Addendum Planning Committee

MEETING OF THE PLANNING COMMITTEE

ITEM NO: 6 PLANNING APPLICATION: 23/00654/F Just Retirement Roebuck House Bancroft Road Reigate RH2 7RP

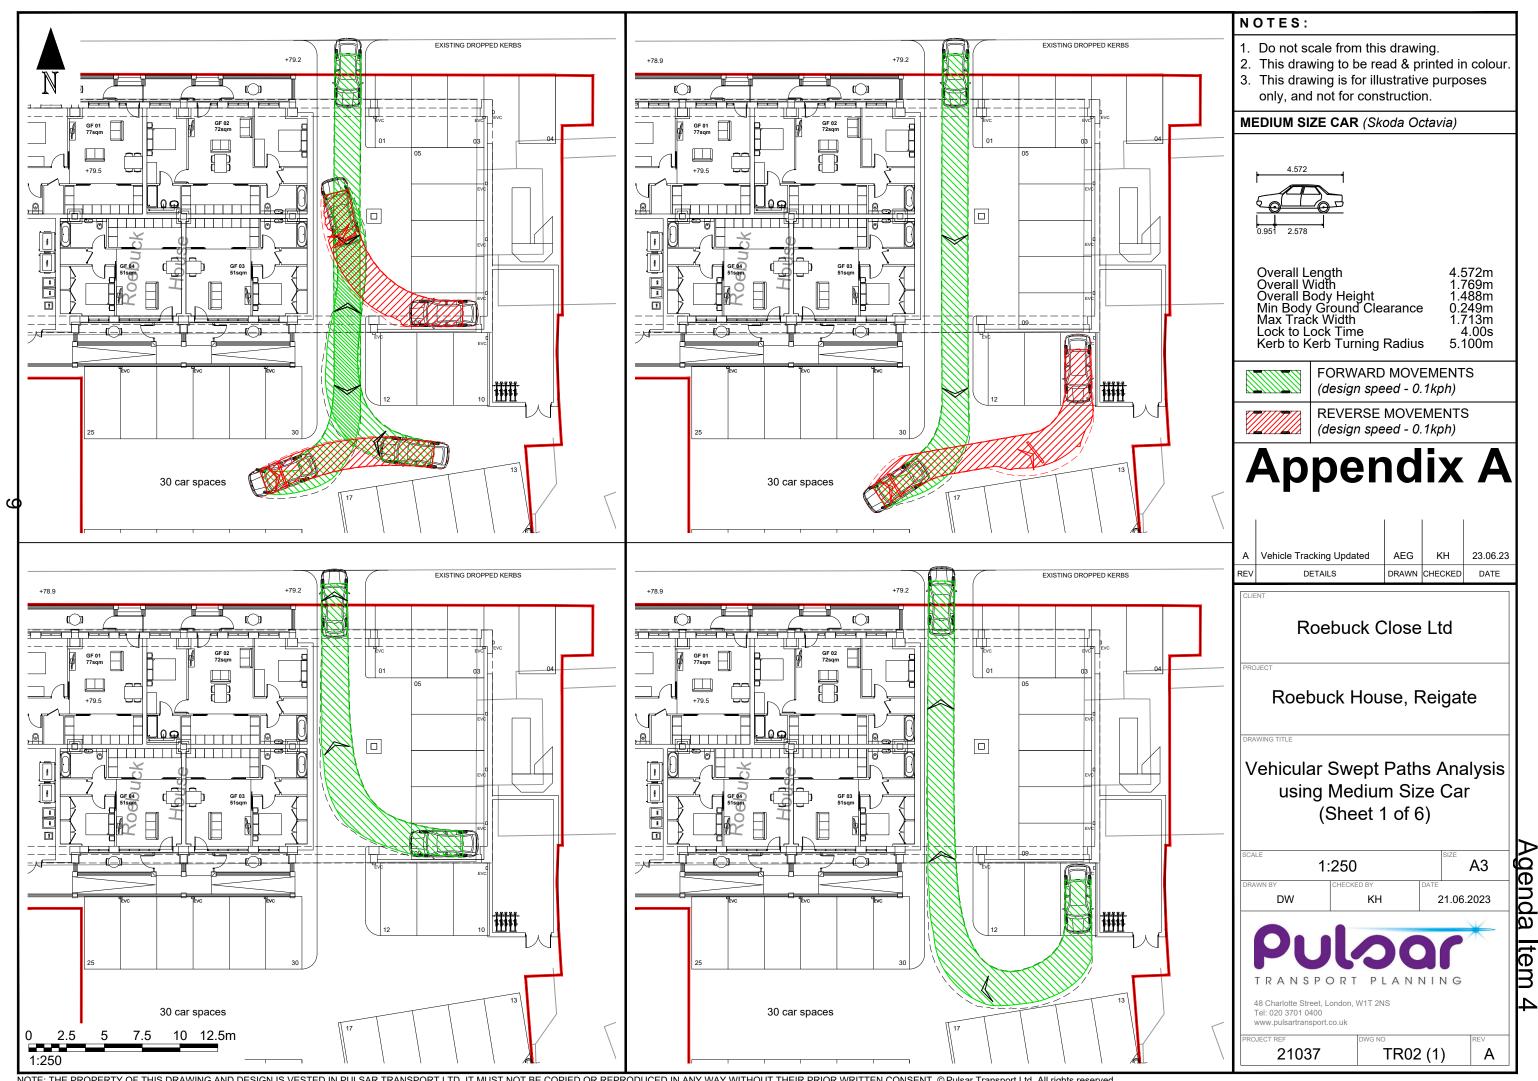
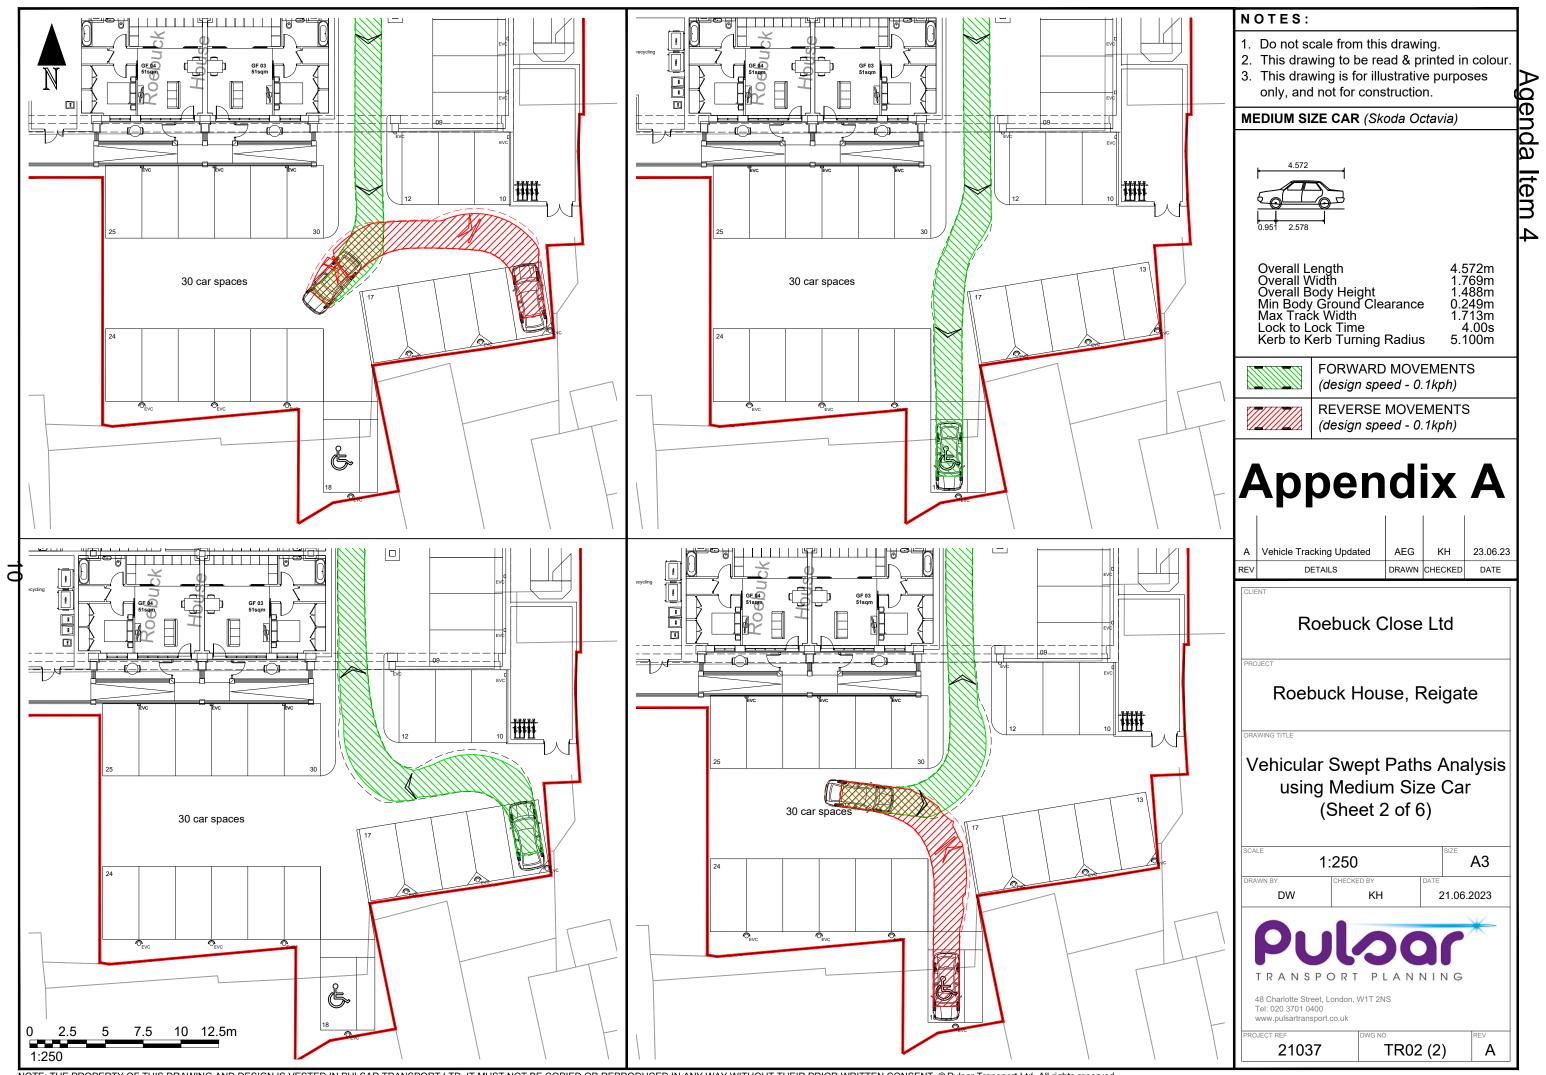
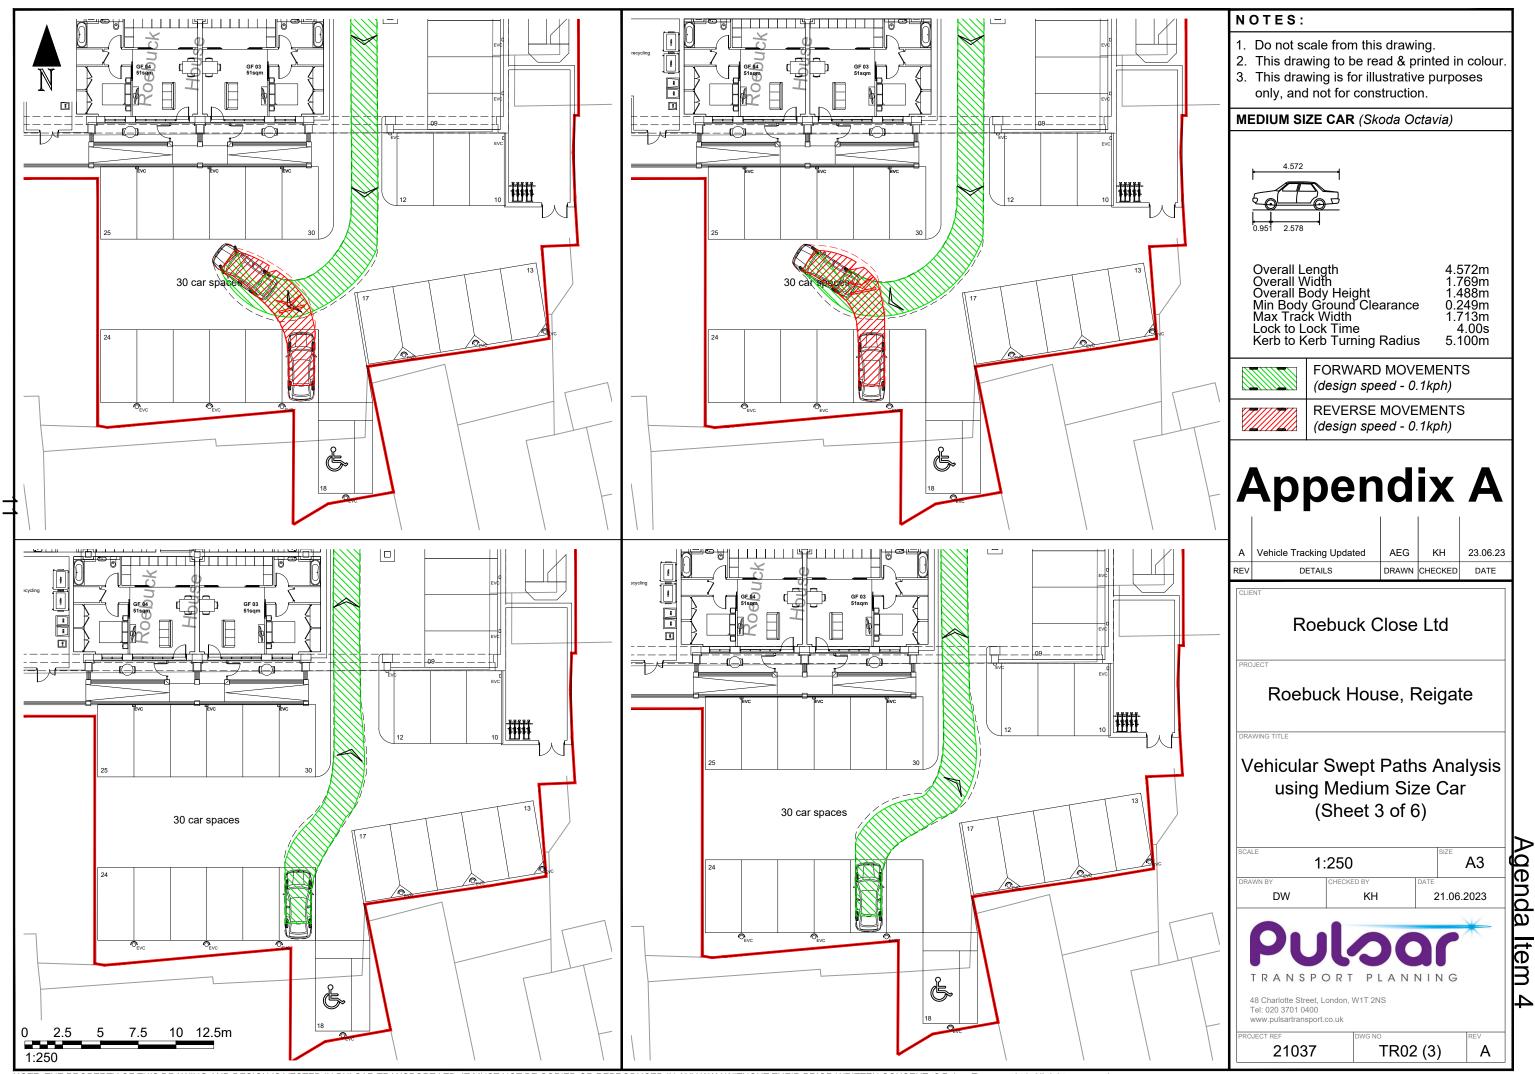
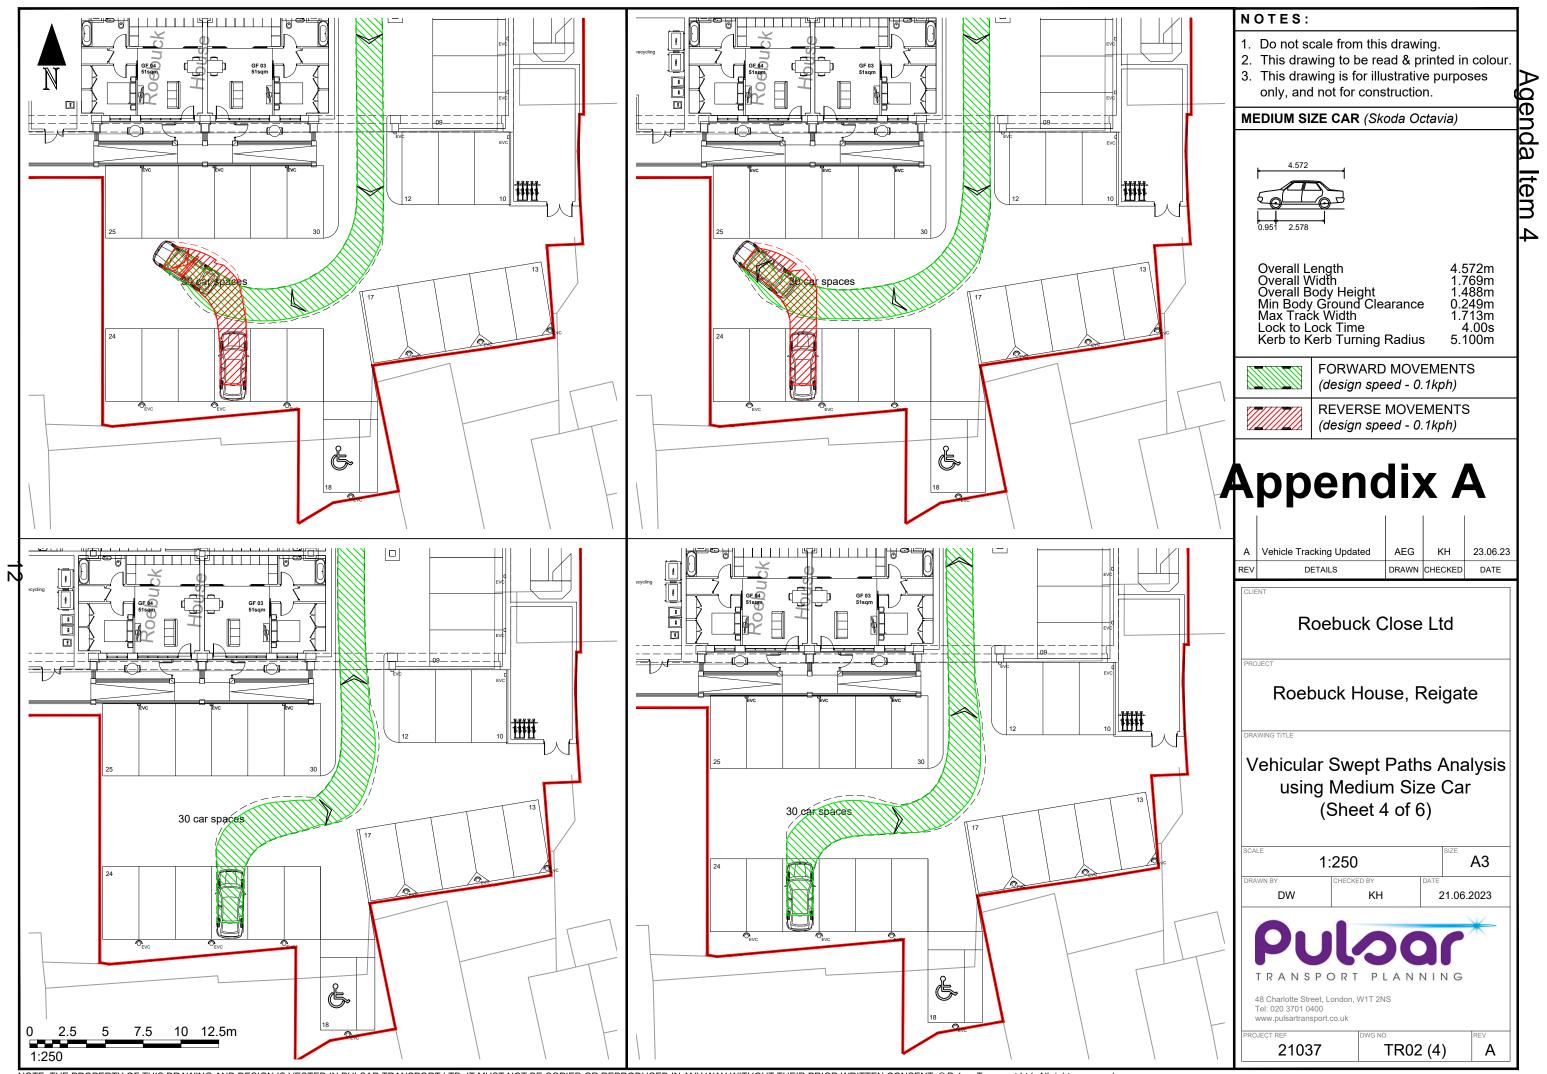
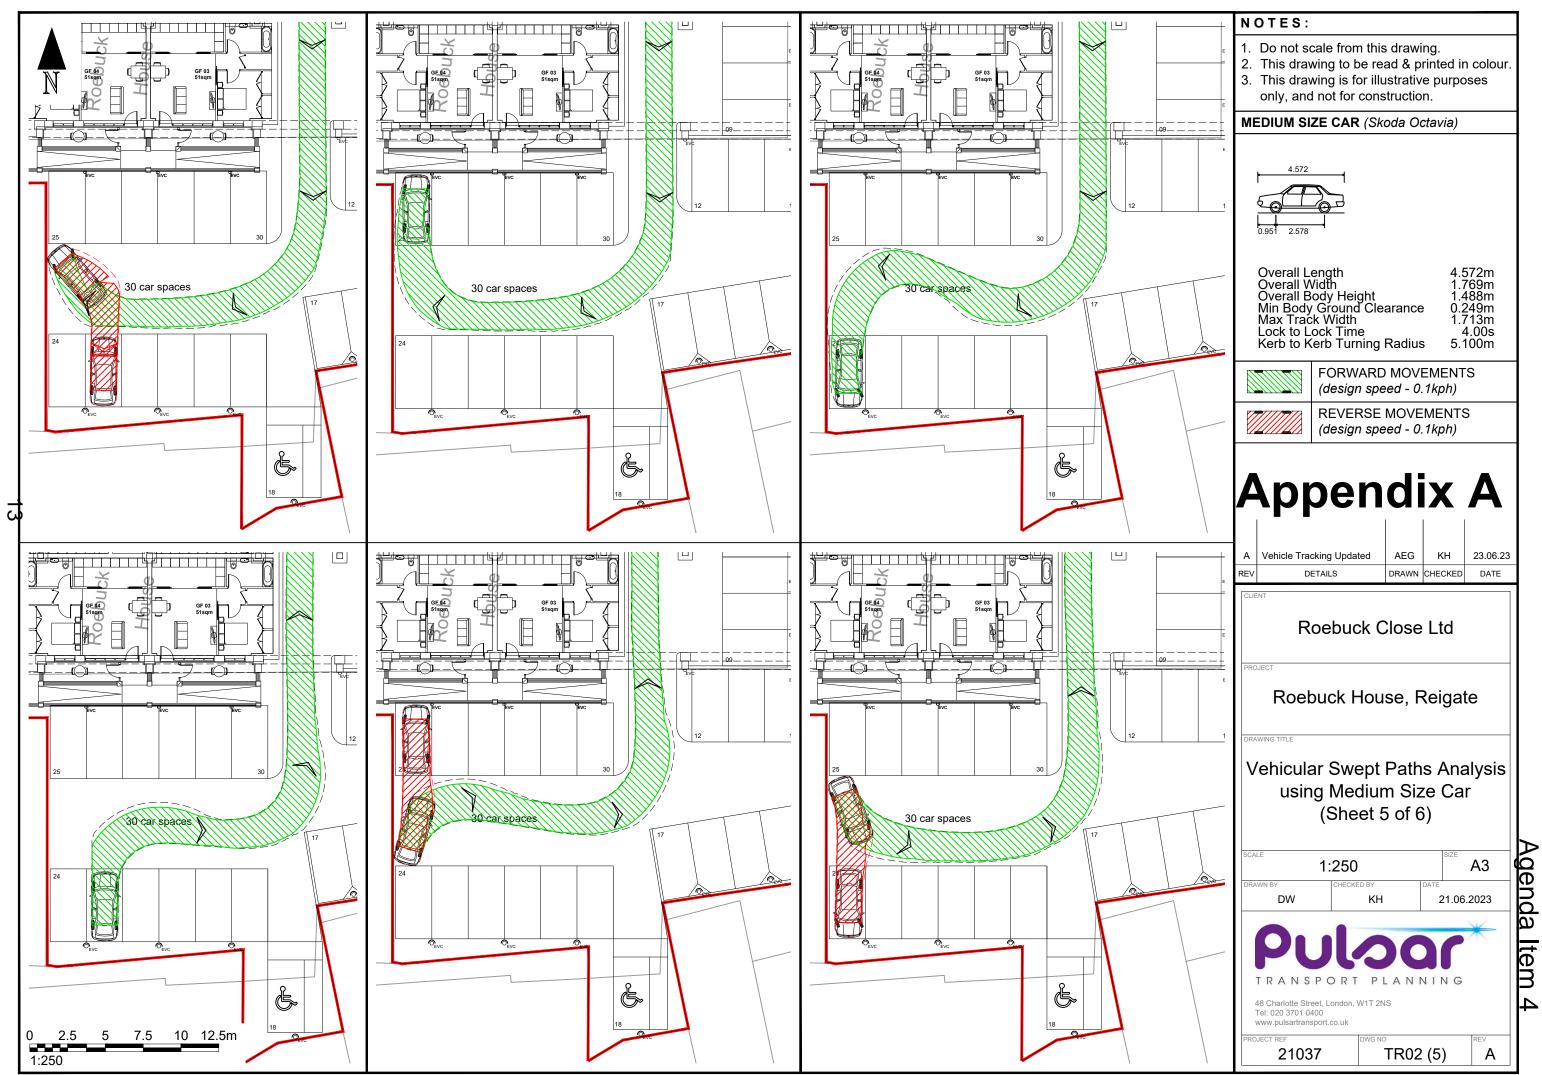
Vehicle tracking plans have been provided demonstrating vehicular movements of a medium sized vehicle entering and exiting a number of proposed parking spaces in both forward and reverse gears. These plans (21037 TR02 A) can be found in Appendix A of the addendum.

Following publication of the report, it has been noted that 3 of the existing parking spaces (1, 3, and 9) as shown on plan number AP261_P101_A, which are proposed for use by future residents of Roebuck House, are impeded by existing pillars within the undercroft of the building. Whilst these spaces are pre-existing and capable of some use, this issue has been reviewed by the County Highway Authority (CHA), who consider that the narrow width of these spaces would make them difficult to enter and exit.

The CHA have advised that if either space 1, 2 or 3 were removed, along with space 9, this would result in a more appropriate layout and would make it clear as to where parking can take place.

To capture the additional spaces and a more optimum parking layout, number and management of the spaces, it is recommended that condition is amended 9 to require a parking layout and management plan.

9. Notwithstanding the submitted plan AP261 P101 Rev A the development hereby approved shall not be first occupied until a revised parking layout and management plan has been submitted to and approved in writing by the Local Planning Authority. The parking layout and management plan shall include numbers of spaces, markings and details of any management including allocation of spaces.
